Form 3160-5 (June 2019)	UNITED STATES DEPARTMENT OF THE INTERIOR BUREAU OF LAND MANAGEMENT	FORM APPROVED OMB No. 1004-0137 Expires: October 31, 2021
SUNDRY NOTICES AND REPORTS ON WELLS <i>Do not use this form for proposals to drill or to re-enter an abandoned well. Use Form 3160-3 (APD) for such proposals.</i>		5. Lease Serial No. NMNM0438001
		6. If Indian, Allottee or Tribe Name

EOG respectfully requests an amendment to our approved APD for this well to reflect the following changes:

Deep Elem 4 Fed Com 753H (FKA 585H) API #: 30-015-48904

PECOS DISTRICT DRILLING CONDITIONS OF APPROVAL - SUNDRY

WELL LOCATION AND ACREAGE DEDICATION PLAT

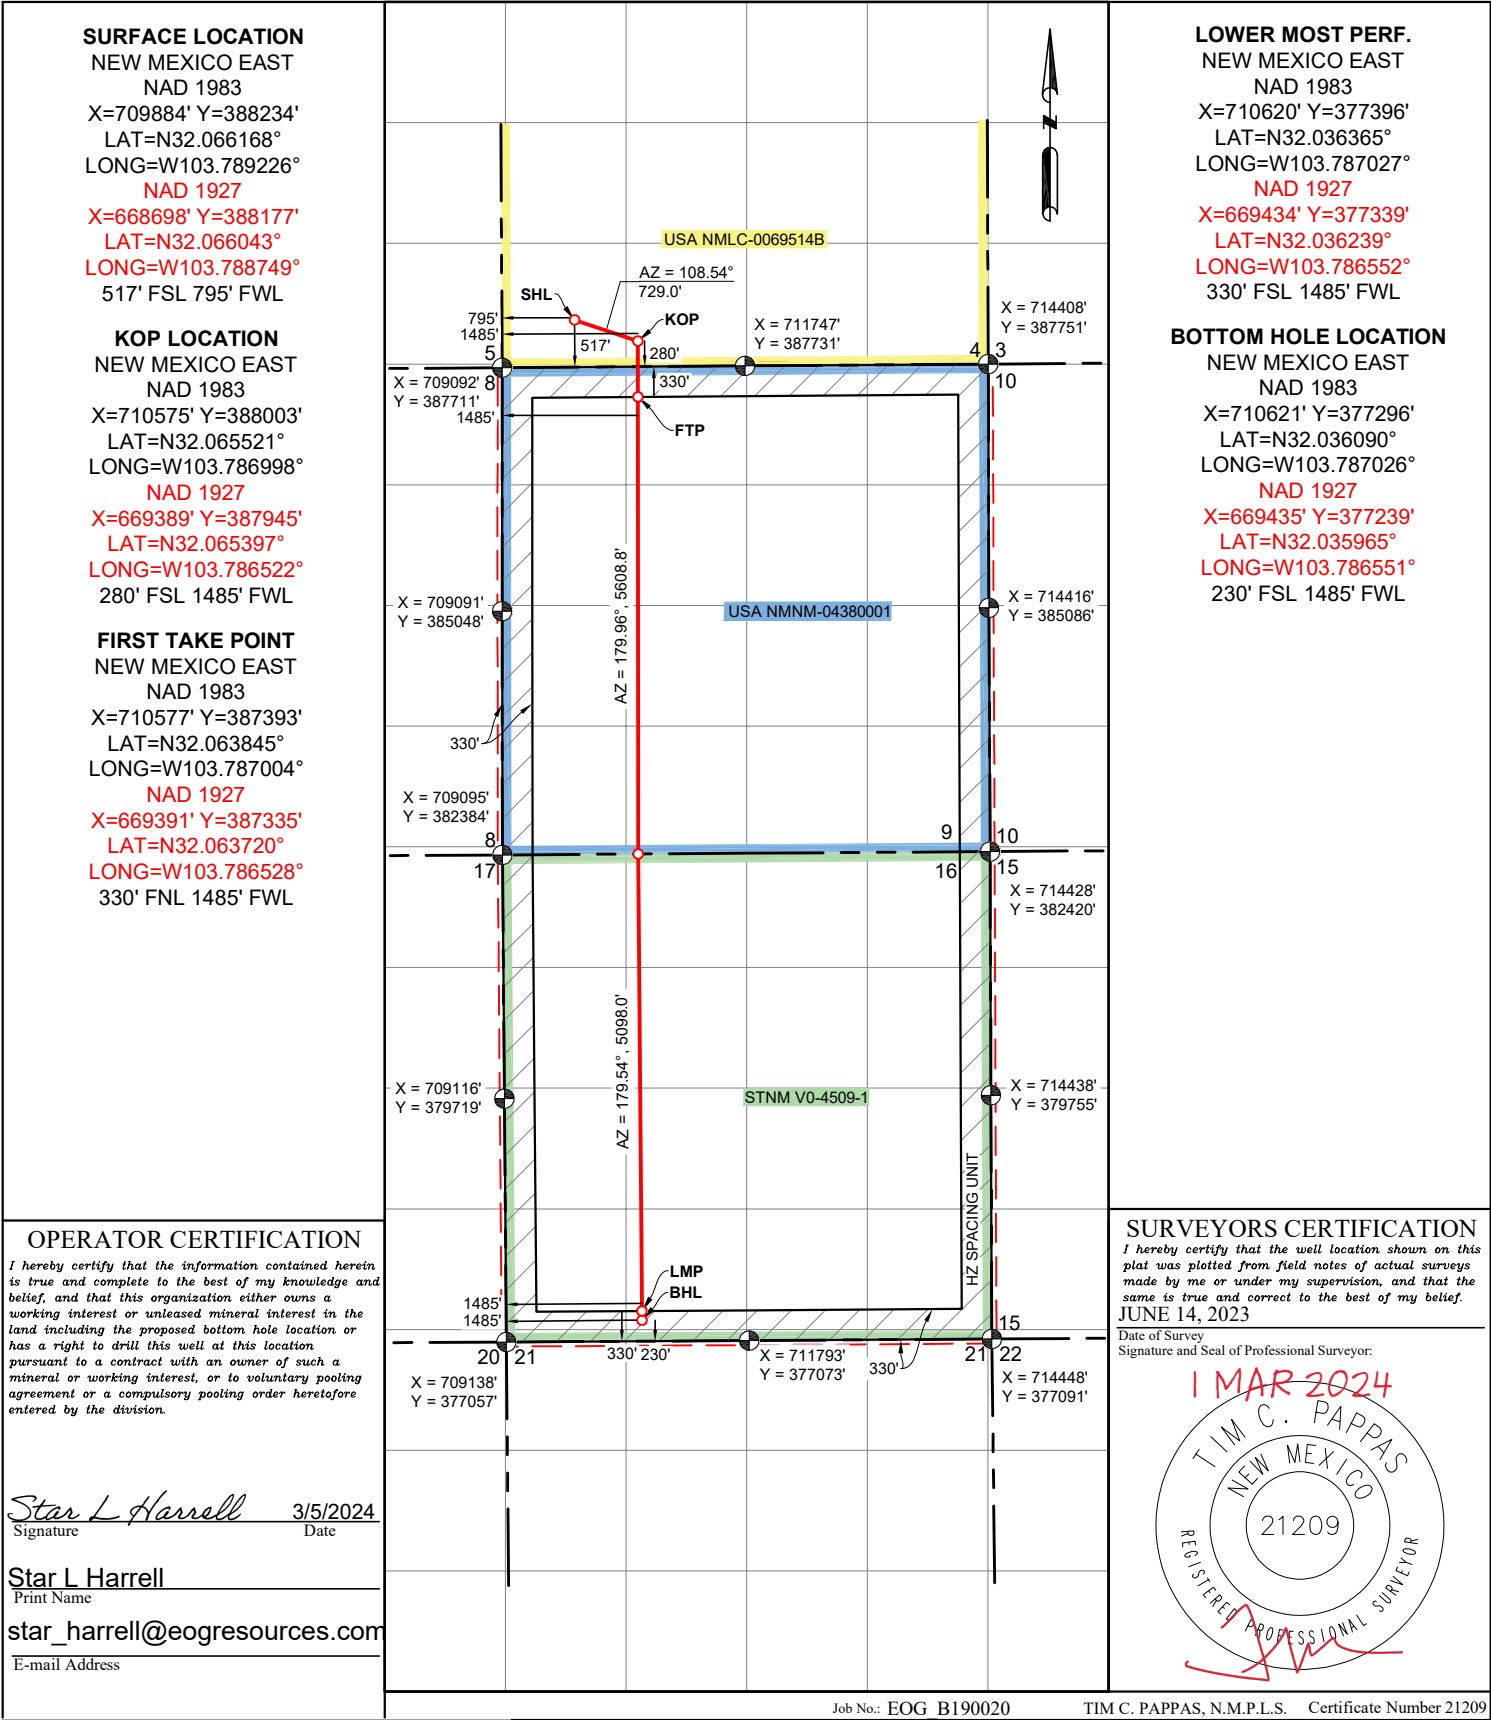
Change name from Deep Elem 4 Fed Com 585H to Deep Elem 4 Fed Com 753H.

Change BHL from T-26-S, R-31-E, Sec 16, 100' FSL, 1265' FWL, Eddy Co., NM, to T-26-S, R-31-E, Sec 16, 230' FSL, 1485' FWL, Eddy Co., N.M.

UL or lot no.	Section	Township	Range	Lot Idn	Feet from the	North/South line	Feet from the	East/West line	County
M	16	26 S	31 E		230	SOUTH	1485	WEST	EDDY
